# How to Determine Revision A or B Intercom Hardware

## Loading Firmware on the VoIP Intercom that is PCB Board Specific

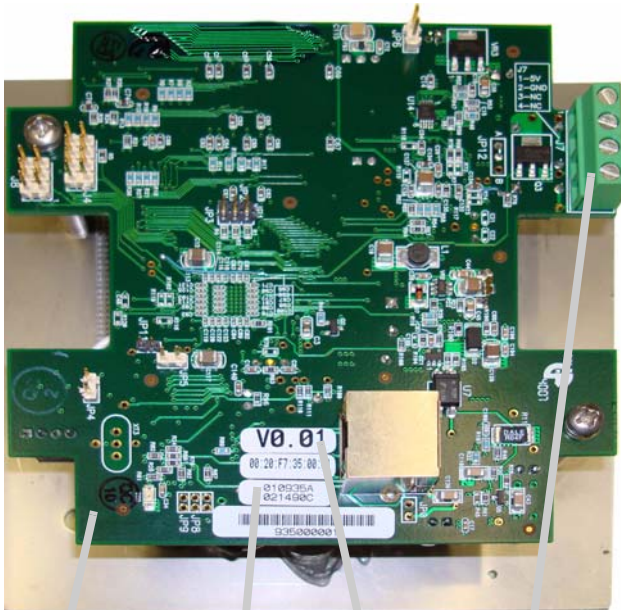
No Intrusion Detector Header  
010935A  
Firmware Version Label less than 3.0.0  
4 Post Header

Intrusion Detector Header  
010935B or above  
Version 3.0.0 Firmware Label  
6 Post Header

The most recent version of the VoIP Intercom (010935B) has some hardware changes that require a different firmware version that is not backward compatible with the earlier version of the intercom (010935A).

Firmware for the 010935B hardware will be identified as version 3.0.0 or above.

Firmware for the 010935A hardware will be identified as a version less than version 3.0.0 (such as V2.01, V2.02, and so on up to V2.99).
